This document describes the changes to the E2900 radio in relation to the application for a Class II permissive change under rules CFR 47 § 2.1043(a), and under the FCC Permissive Change Policy 178919 DO1 v06

The change involves replacing the obsolete National Semiconductor PLL IC LMX2352 with Analog Devices PLL IC ADF4212L. Both parts are Duall PLL IC, and perform the same function in the circuit. The function of the IC is to generate the Intermediate Frequency (IF) and Local Oscillator (LO) signals for receive, and to generate the rf signal for transmit operation.

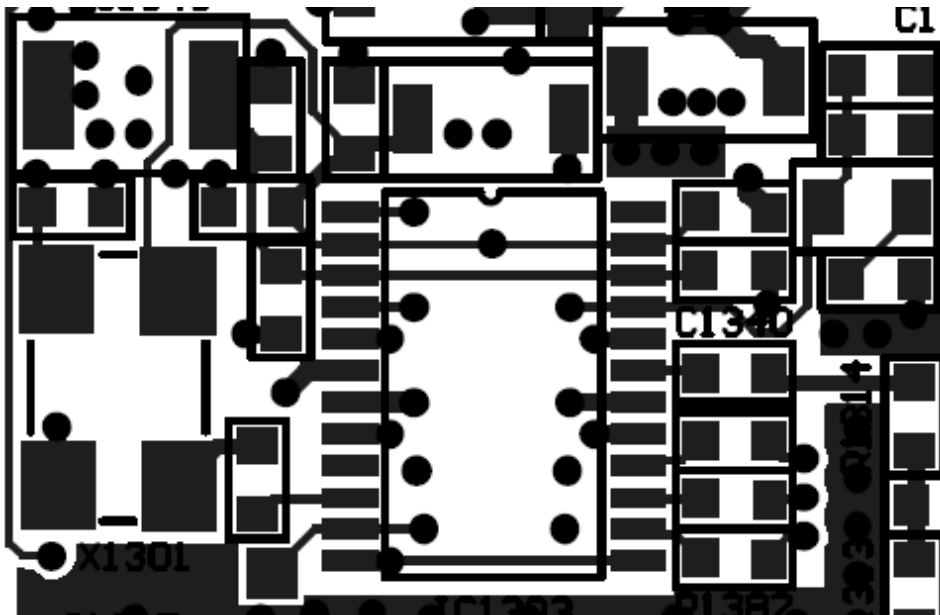
- 2) The new chip has the same basic function as the old chip, from an external perspective (internal circuitry may differ).**

It has the same basic function, although the internal circuitry differs. The original device operated as a fractional PLL. This device operates as an integer PLL.

Previous Revision

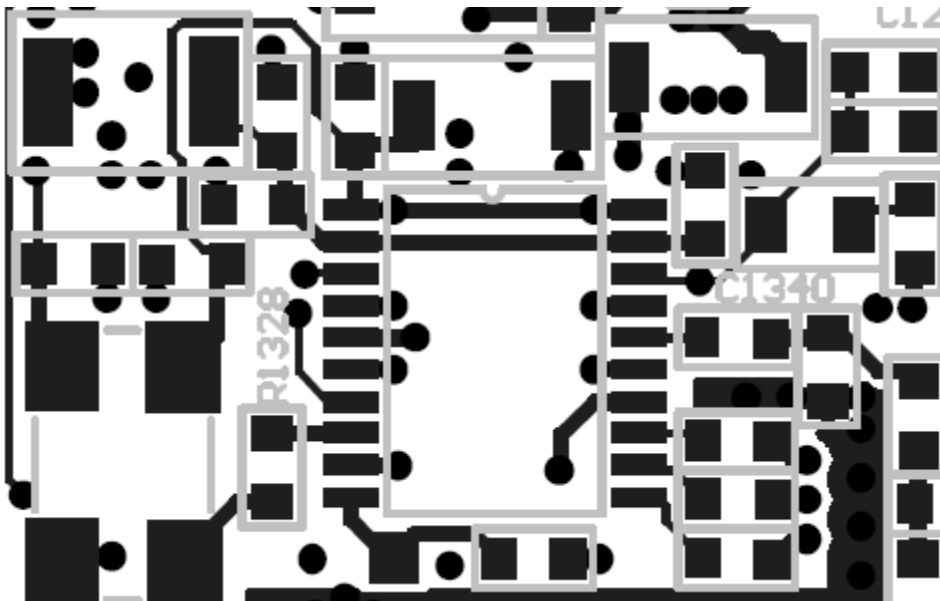
- 4) The same conditions apply when a small area (approximately the same area as the chip) of the PCB is replaced with an equivalent chip.**

The area of the PCB that has changed is effectively the same as the chip. The diagram below shows the PCB changes. It can be seen that the layout changes are minimal, and the connections to the Chip are pin-for-pin.
